Docket Item # 5 & 6
BAR CASE # 2014-00028
2014-00029

BAR Meeting March 5, 2014

ISSUE: Partial Demolition and Alterations

LOCATION: 1201 E Abingdon Drive

Roof Top Level
Sheet 1
12/9/13
Not to Scale

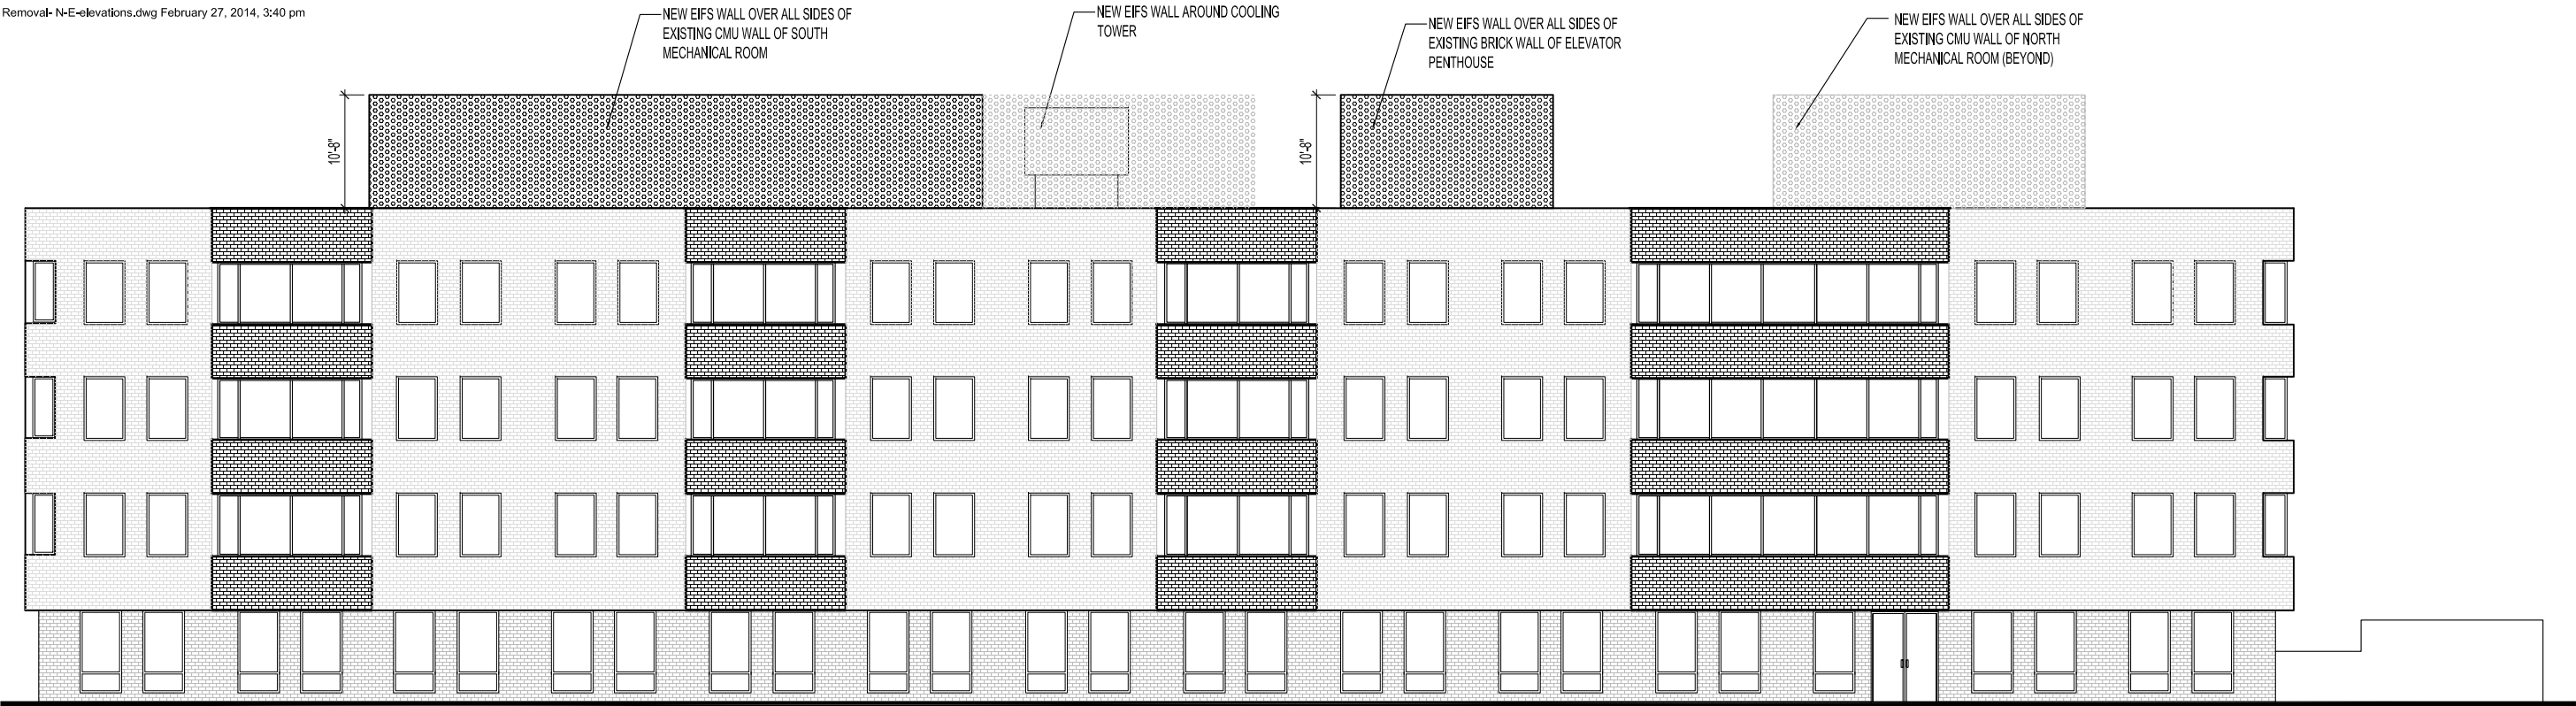
1. The elevator penthouse remain unpainted red brick that matches the building;
- 1.) The new EIFS may not exceed 15 feet in height from the top of the roof; and
- 2.) The new screening must be painted a light grey color with final approval of the color by staff.

Staff supports removal of the existing mansard screen because it will simplify the building and reduce its visible mass. While the existing mechanical penthouses are themselves undeniably large, the existing condition photographs seem to indicate that the building mass will still be substantially less if the screen is removed. Staff finds that none of the criteria from section 10-105(B) of the zoning ordinance are met and that a Permit to Demolish should be granted.

As to the new EIFS finish material proposed for the existing CMU penthouses, brick veneer matching the brick wall below would likely draw attention to the irregularly placed penthouses. EIFS has been used on many of the penthouses in the Carlyle development, as long as the finish reflected the architectural detailing of the walls below. In this case, there is no detail on the brick walls below. Therefore, consistent with the *Design Guidelines*, staff supports the applicant's request to finish the EIFS surrounding the mechanical rooms in a light grey color to blend into the sky, rather than become an architectural feature. That said, the existing elevator penthouse is currently clad in unpainted, red brick and staff finds no reason to cover its walls with EIFS. The elevator penthouse is the smallest of the three, and the least visible from the Parkway.

Recommendation: Request the Board of Architectural Review deny the request for removal of existing "Roof screen", and instead require repair and maintenance of the existing "roof screen", with replacement of missing "roof" panels, and revised design modifications for improved wind resistance.

If the BAR instead approves request to remove the existing "Roof Screen", request an off-white colored capstone (either cast stone or painted sheet metal) on the entire parapet wall around the flat roof and a brick facing for penthouse and cooling tower walls.
